**ZONING MAP CHANGE
STAFF REPORT**

Owner / Applicant: R/P LLC II, LTD

Site Location: 2500 River Park Drive Mapsco: 74Z

To: "PD/R1" Planned Development for all uses in "R1" Zero Lot Line/Cluster with the following waivers: less than minimum lot size of 3,300 sf, less than 5 ft. side yard setbacks, and less than 33 ft. lot width at the building line, site plan included

A PRELIMINARY SITE PLAN FOR
RIVER PARK
CONTAINING BLK 1, LOTS 1X, 1-30; BLK 2, LOTS 1X, 1-3;
BLK 3, LOTS 1X, 1-10 AND BLK 4, LOTS 1X, 5X, 1-11
EXISTING 'G' ZONING
BEING A 6.55 ACRE TRACT OF LAND LOCATED
IN THE E. WILBURN SURVEY, A-1635
SITUATED IN CITY OF FORT WORTH, TARRANT COUNTY, TEXAS

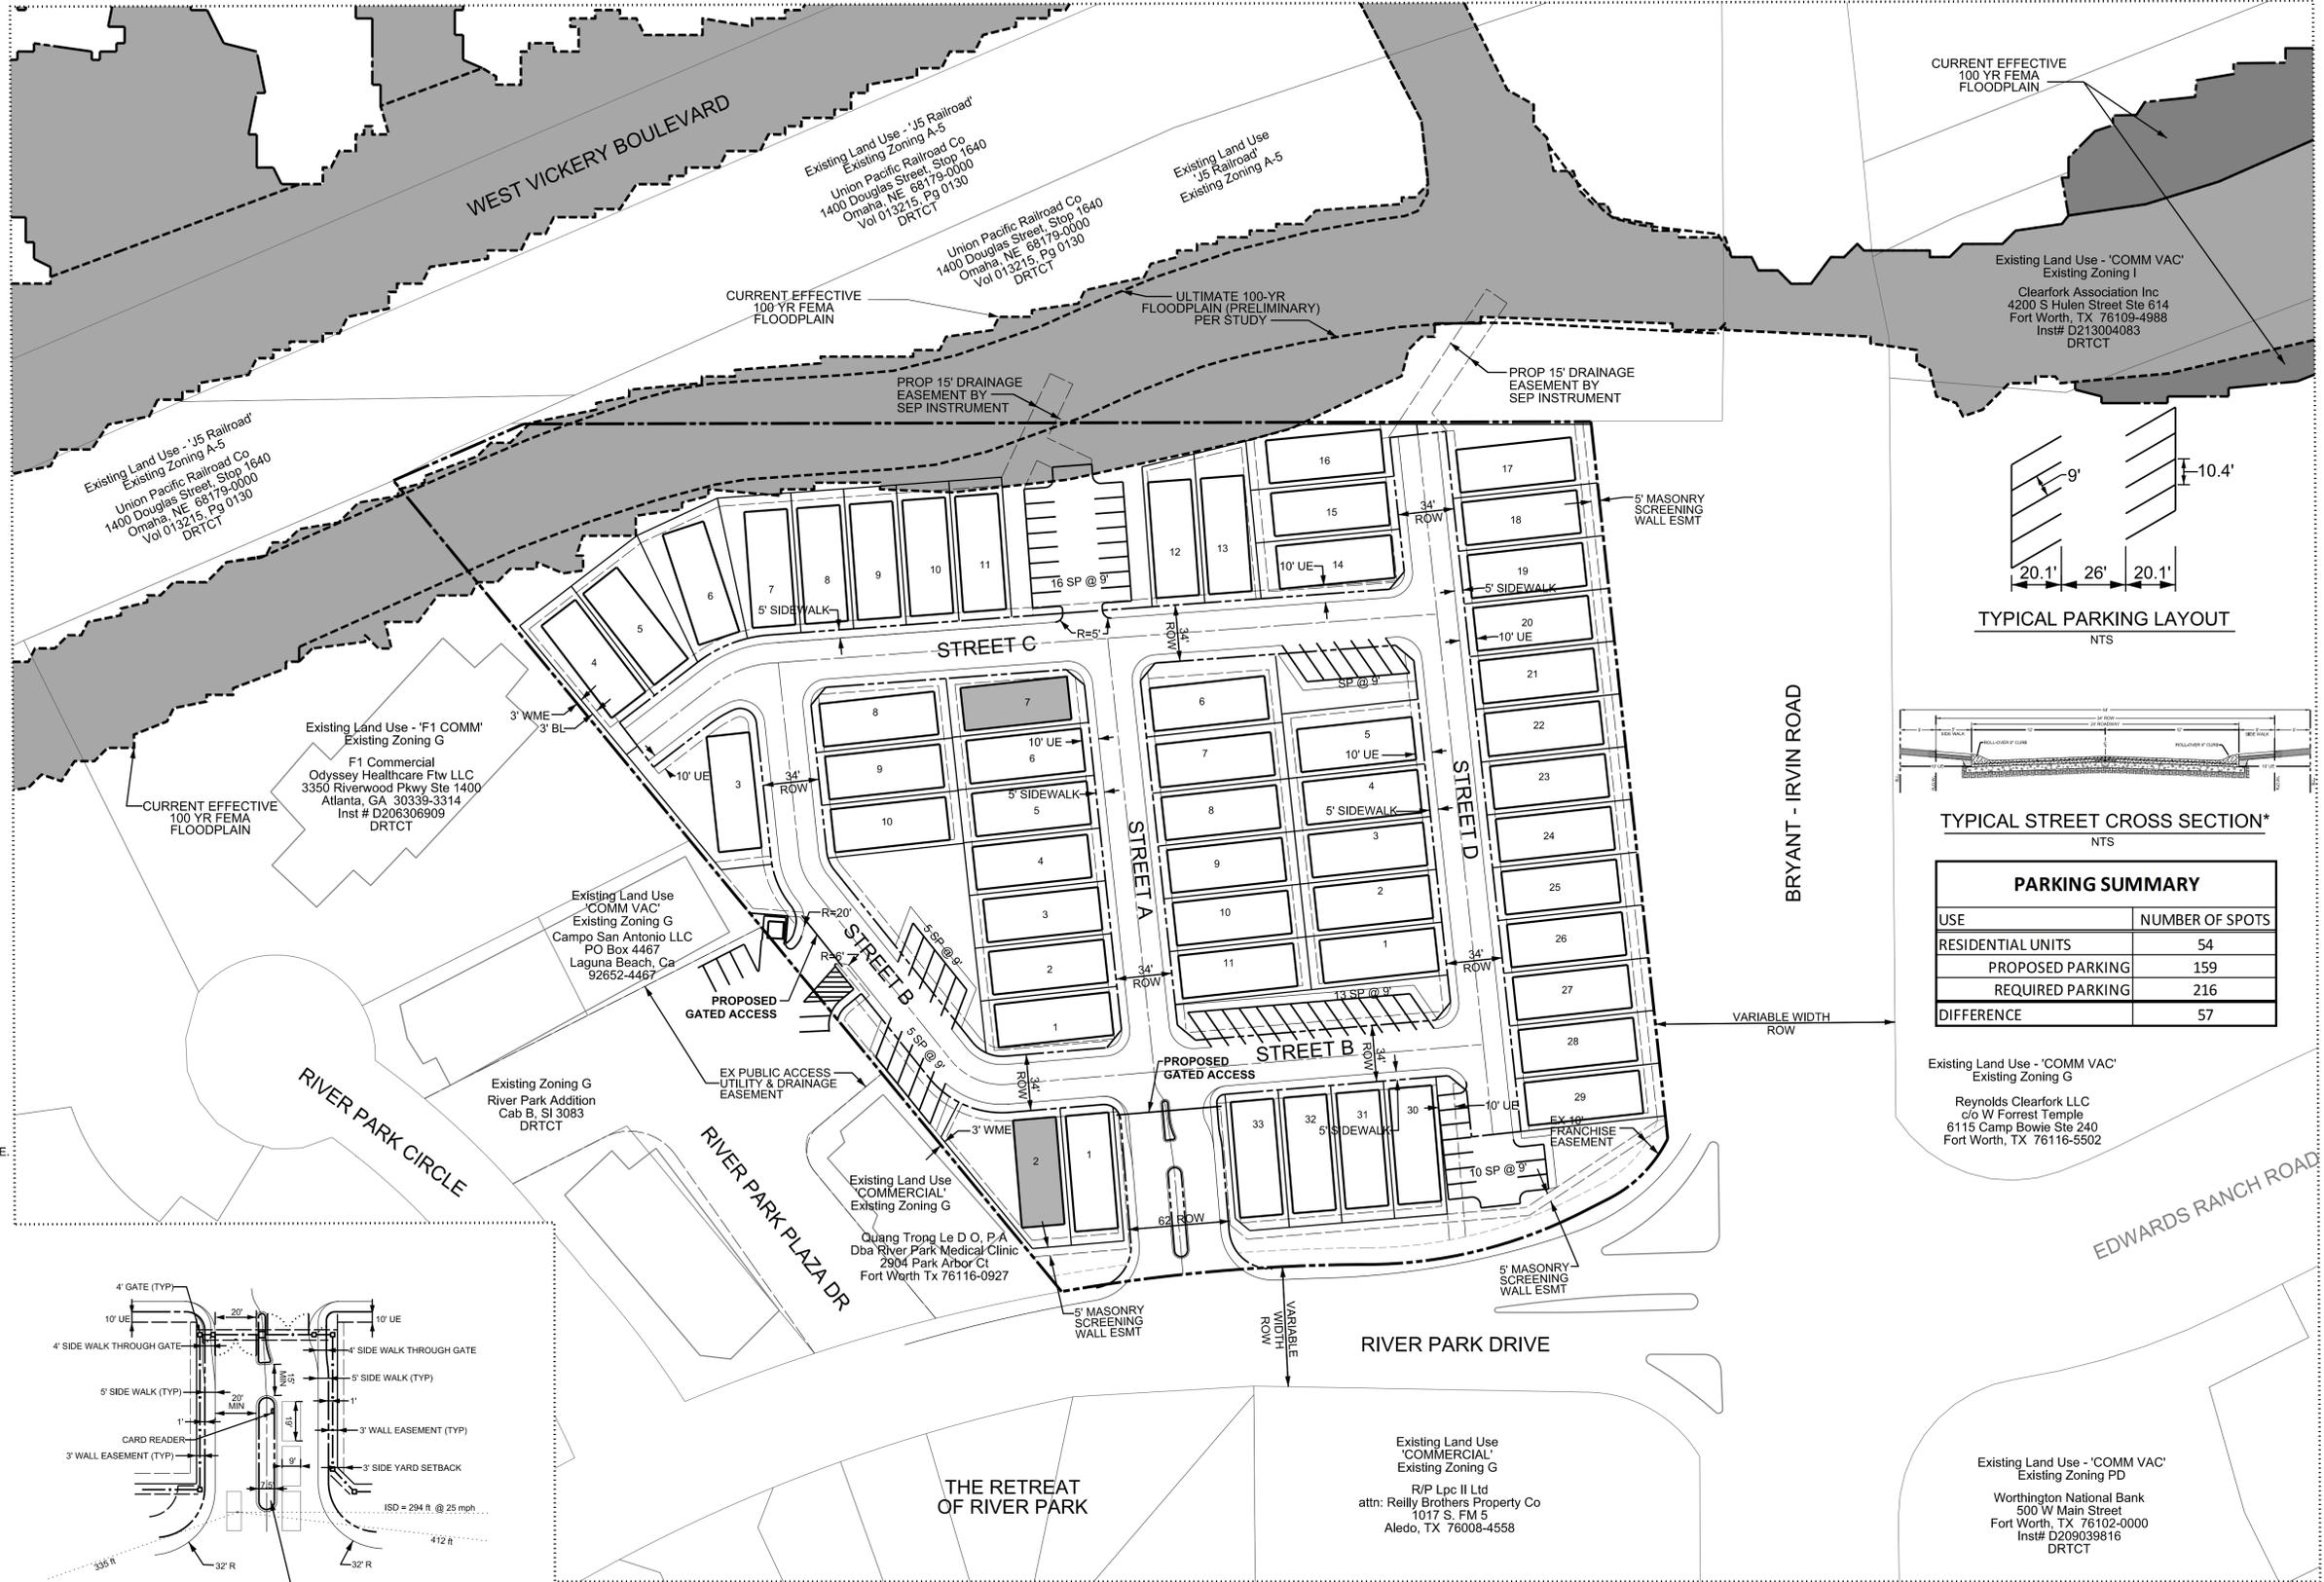
The site plan as submitted is not in general compliance with the R1 zoning regulations. The applicant is requesting waivers for the following items:

1. Four parking spaces required behind the front build line (on limited local street).
2. Required parking cannot be counted within easements
 - a. Several parking spaces are located within proposed 10' utility easement and 15' drainage easement
3. The minimum lot size for R-1 zoning is 3,000 sf (waiver requested)
4. 5 ft. required rear setback (waiver requested)
5. 33 ft. lot width is required at the building line (waiver requested)
6. Structures are prohibited within easements (i.e. dumpster, single-family) (cannot be waived through the zoning site plan process)

1. Two access points (ingress and egress) are required when 30 residential units are platted. This proposal for 54 units provides only one access point and an "emergency vehicles only" drive.

2. A limited local street, the narrowest public or private street allowed, requires a 25-foot roadway (back of curb to back of curb) centered in a 40-foot right-of-way rather than the proposed 24-foot roadway (back of curb to back of curb) in a 26-foot right-of-way.

3. A cul-de-sac or series of interconnecting streets that form a closed "circle" in which there is only one outlet shall not serve more than 30 residential units nor exceed the maximum length of 650 feet, rather than the proposed 54 units with a street length in excess of 1,200 feet.

4. Four off-street parking spaces are required for each residential unit on a limited local street (216 spaces including garage parking) rather than the 143 spaces provided.

5. Four-foot concrete sidewalks are required on both sides of all public and private streets. The proposed development does not provide sidewalks.
6. Front entry garages are prohibited for residential lots less than 50 feet in width. Driveways shall be either by rear entry from an abutting side or rear alley or by a common share driveway centered over the common lot line between adjacent dwelling units. The site plan reflects front entry garages each with a 19-foot wide driveway on a 32-foot wide lot.

7. Limited local streets require a paving flare out (28 feet by 40 feet) within the street right-of-way at the midblock location. No flare outs are provided.

8. At least one curb length of not less than 20 feet for every 2 dwelling units on a limited local street is required. The site plan reflects 13 feet of curb length.

9. Additional right-of-way dedication is required for River Park Drive, an arterial street in the Master Thoroughfare Plan.
10. It appears from the site plan that the proposed street design and the location of intersections on River Park Drive do not comply with various technical design criteria. Additional waivers of

1. Their initial problem of running the lines in the street were resolved, but after it was pointed out the inlets would be too close to the building they proposed placing a TxDOT inlet. These inlets are basically backwards to our City inlets, but they would work. But now the lines are back in the street and they have not been accounted for since they will again impact the water and sewer. So they have not proven the lateral lines will work and not interfere with the other utilities.

2. The inlets are only 6 feet from the building. This is not enough clearance. Anytime work is done there is a very real possibility of disturbing the foundation of the building. Any crack in a wall will be blamed on the City. There is also the problem of equipment working in that close quarters and the very real possibility of hitting the building. When these machines are about 7'+ wide plus the extension supports, the supports would have to be against the building, which usually mean hitting the building. It is simply not enough room to maneuver equipment to do work behind the back of curb.

3. Since the building is only 5 feet from the ROW, normally the water for the 100 year is carried to the ROW. The criterial says there should be 2' of freeboard above the 100 year flood level, but even we agree that is probably not meant for the street 100 flood level. We do all agree however, 6" above the 100 year is valid and they do have very low flows. Even if they kept all of the water in the gutter line, for it to raise 6" to get the building above the flood level, in 6 feet, you need an 8.3% grade which is very steep for a driveway approach and probably will not work.

1. Local residential streets require 50' ROW. A limited local street of 40 ft. is permitted in single-family developments; however the maximum units served by a limited local loop street is 30 units.

2. The proposed lot coverage does not allow for sight visibility as vehicles exit driveways into the travel path of cars within the subdivision.
3. There are no proposed sidewalks within the residential development.

4. Raised curb and gutter are required for all city streets.
5. Intersections sight distances must be adequate. Horizontal geometry, vertical geometry, and intersection angles must provide adequate sight distance. The grade difference as Bryant Irving approaches River Park Drive may preclude drivers from seeing drivers entering and exiting the proposed first access drive along River Park Drive if vehicles are stacking into River Park right of way as they await vehicles maneuvering within the on-street parking spaces proposed at the entrance of the development.

6. Driveway location must not interfere with intersection function. Ensure adequate visibility is available after lots enter the subdivision and approach vehicles exiting driveways along Street B adjacent to the gated access entry.

7. Gated entrances into secured areas must be designed in accordance with TPW's "Traffic Engineering Design Standards and Policy Guidelines". Provisions for an acceptable turnaround must be made. Provide details on final plat. The access closest to the intersection of Bryant Irving and River Park Drive does not provide stacking space, but is proposed as ingress and egress to the site.

8. Head-in parking must comply with ordinance #17517. The proposed head in parking at the first access (Street D) are located 5ft. from the driveway approach into the subdivision.

1. Because parking cannot be continuously enforced, the Fort Worth Fire Department is concerned that the 24' wide drivable portion of the streets are an insufficient width considering the available parking shown in the submitted site plan. Experience has shown that accessibility can be difficult during emergency situations for fire apparatus when cars park along the side of the street. Adding to this, if cars were to park along the side of the street on either side of the 24' wide roadway (as shown in the 'Typical Street Cross Section'), that would reduce the available street width to below the Fire Code minimum of 20' wide unobstructed access.

2. It is a strong concern of the Fort Worth Fire Department that if the eastern secondary access ROW is needed by emergency personnel for access, this will be a hazard to drivers turning right off of the southbound side of Bryant Irvin Road onto River Park Drive as fire apparatus are forced to stop suddenly for a very sharp right turn into the subdivision.

3. The applicant has shown no indication to the Fort Worth Fire Department that unobstructed access, as required by the City of Fort Worth's Fire Code, can be supplied to all residential lots within this subdivision at all times.

4. The 24' Turning Radius shown on the site plan submitted to the Fort Worth Fire Department does not meet the minimum requirement of Section 503.2.4 of the City of Fort Worth Fire Code.

1. Street dedication exclusive for water and sewer easement
2. Encroachment agreement is required for gates, over water and sewer
